# UNITED STATES PATENT AND TRADEMARK OFFICE

10/623,933

**Office Action Summary**

## **DETAILED ACTION**

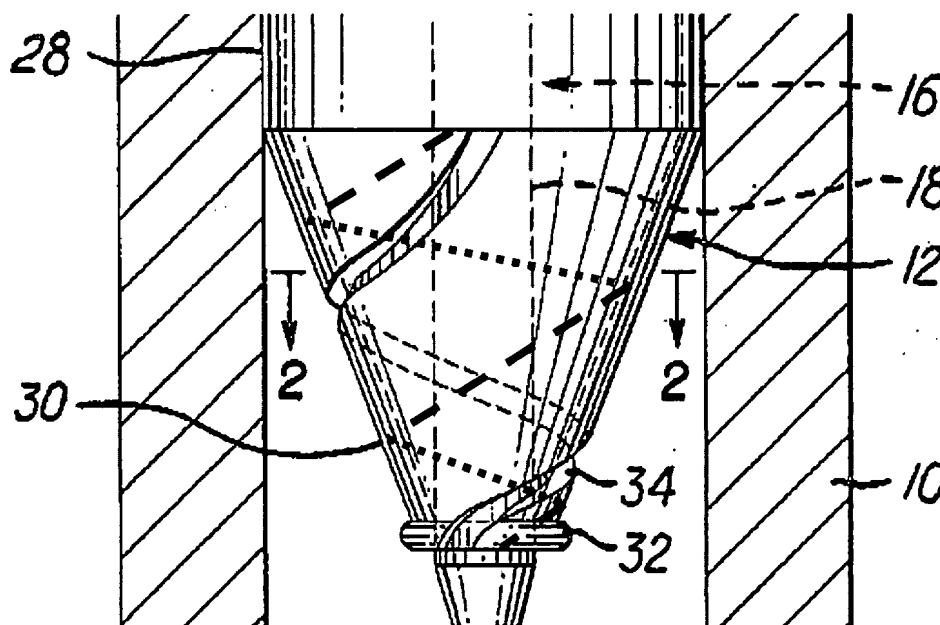
Carluccio '298 teaches a tubular member (10) having an open end, and a wiping cap (12) including a cup-shaped conical wiper, and a frustum (26) for mating with the tubular member. Examiner notes the wiper forms a seal at the apex around the applicator head (22), which alternatively can be read as forming a substantial seal because it tapers to a narrow opening. Also, Examiner notes the wiper appears to make more than one full revolution. See the dotted lines below whereby it appears the wiper

actually makes almost two revolutions. Examiner notes the dashed line represents the frontal path, and the dotted line is the path as it is traced behind the cone. Also, note the very bottom of the line is difficult to see, but can be seen adjacent the line for element (32). Finally, Examiner notes the spiral cut (34) appears to make one full revolution. It is suggested the Applicant amend the claim to better define the structural differences over Carluccio '298 in view of this analysis.

Examiner notes the figure provided above, whereby the dotted lines drawn by Examiner make a complete circumferential loop around the brush, and therefore are in complete circumferential contact. Examiner furthermore notes Applicant's own figures 16-17, whereby it can be seen the pipette is not in complete contact with the entire wiper, only a portion of it, and that Carluccio '298 would appear to function in a similar manner.

Examiner notes the figure provided above, whereby the dotted lines drawn by Examiner make a complete circumferential loop around the brush, and therefore are in complete circumferential contact. Examiner furthermore notes Applicant's own figures 16-17, whereby it can be seen the pipette is not in complete contact with the entire wiper, only a portion of it, and that Carluccio '298 would appear to function in a similar manner.
